# APPLICATION

## PERCOLATION TESTING

HOWARD COUNTY HEALTH DEPARTMENT  
BUREAU OF ENVIRONMENTAL HEALTH  
3525-H ELLICOTT MILLS DRIVE/ELLICOTT CITY, MARYLAND 21043  
TELEPHONE: 313-2840

SUBDIVISION Hough Property Lot 6 Resubdivision LOT NO. 6

Copy of Signed  
perc cert  
plat

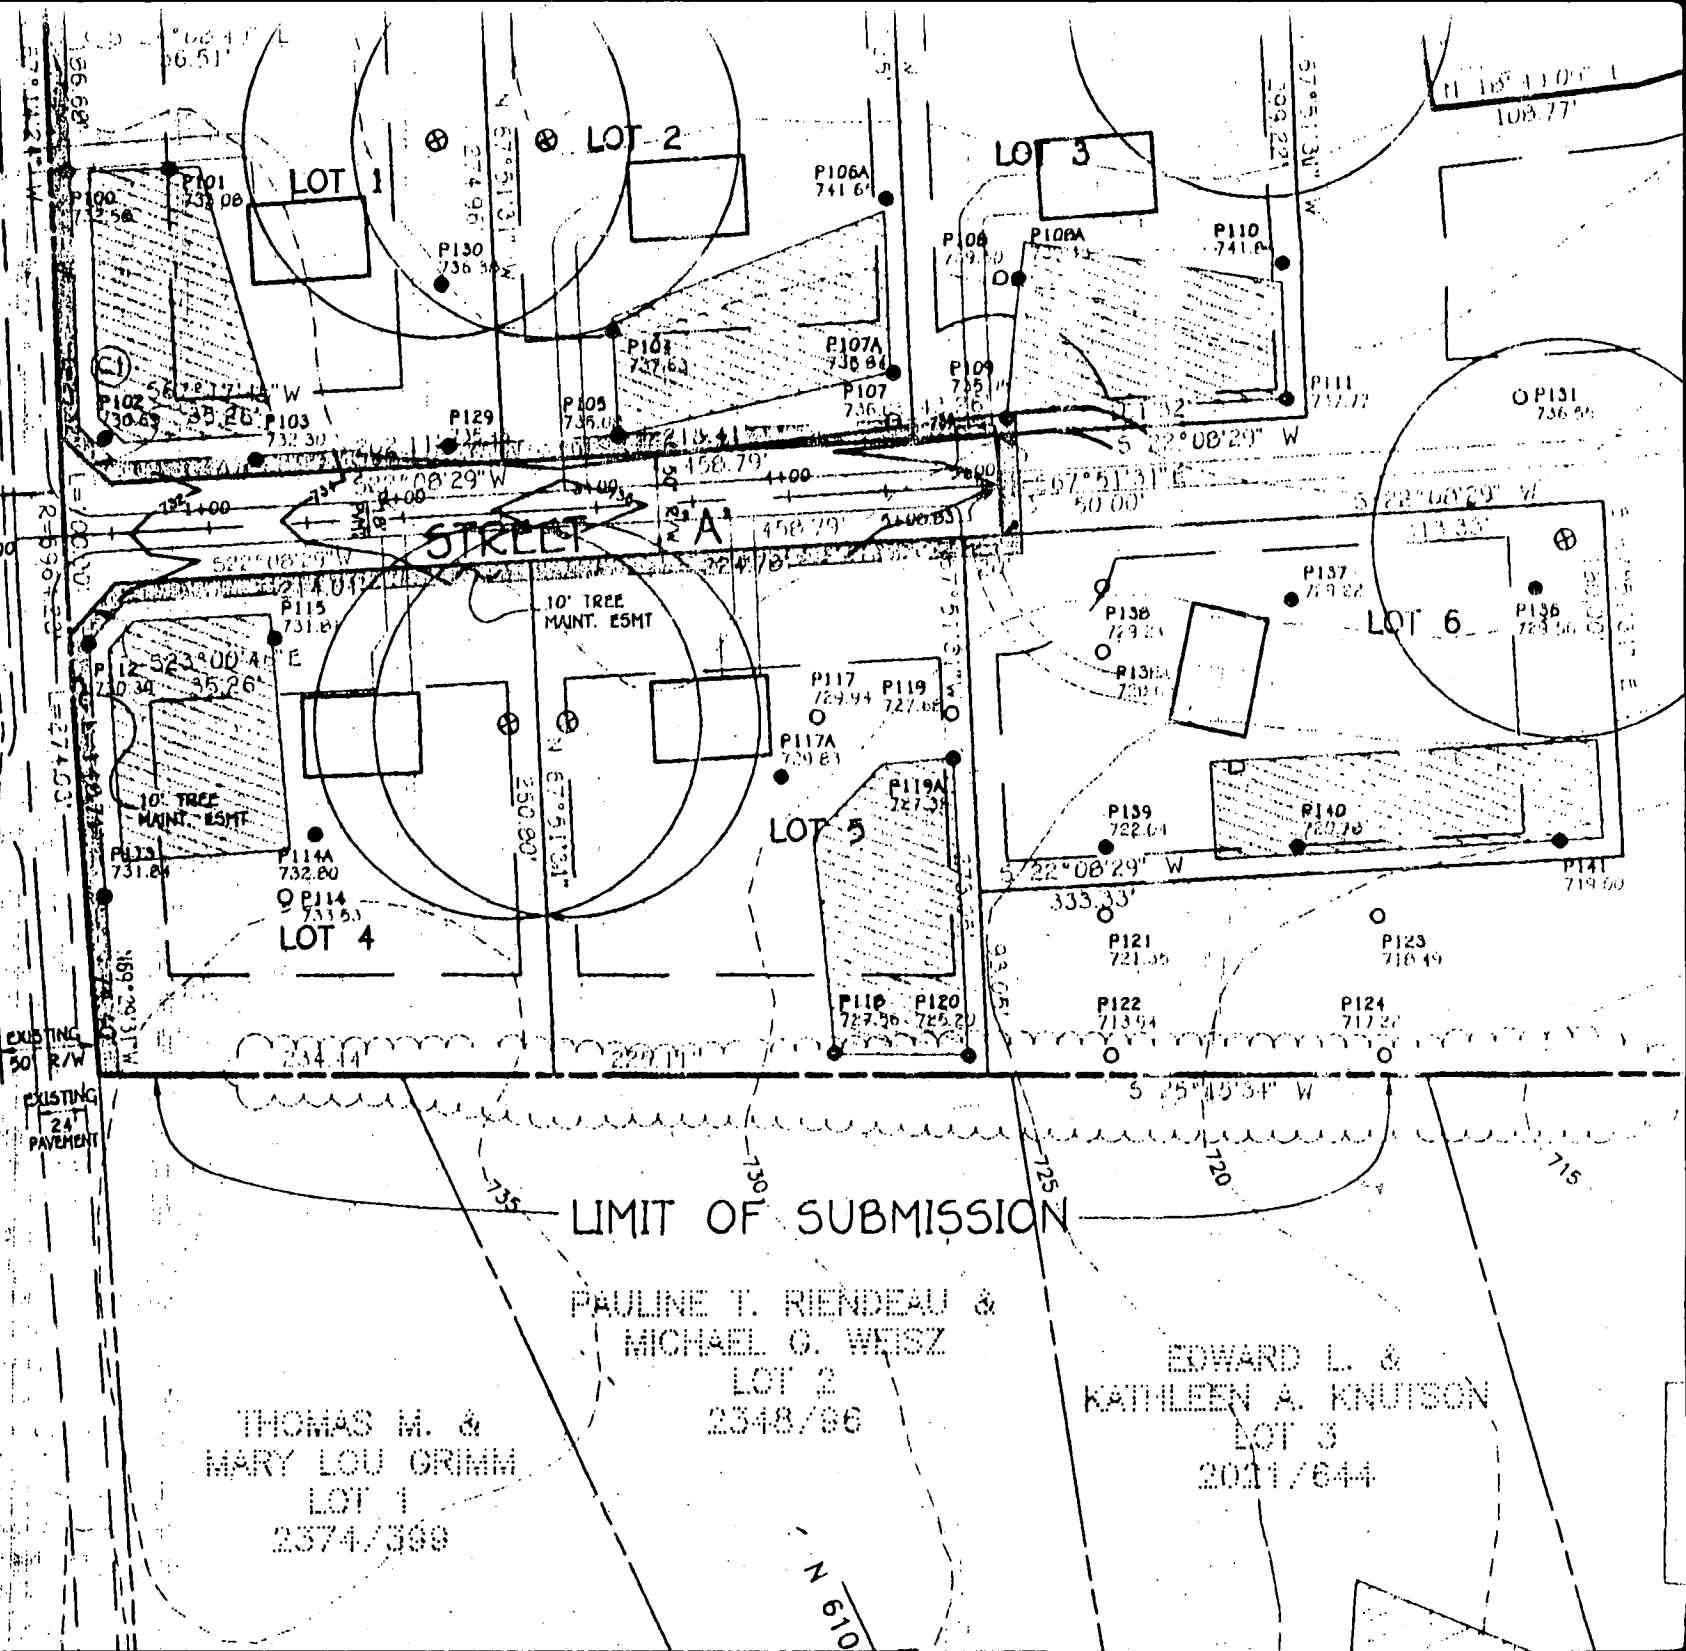
HELEN J. SMITH  
LOT 4  
26/620  
THERE IS NO WELL ON  
LOT WITHIN 100'  
THE PROPOSED DEVELOPMENT
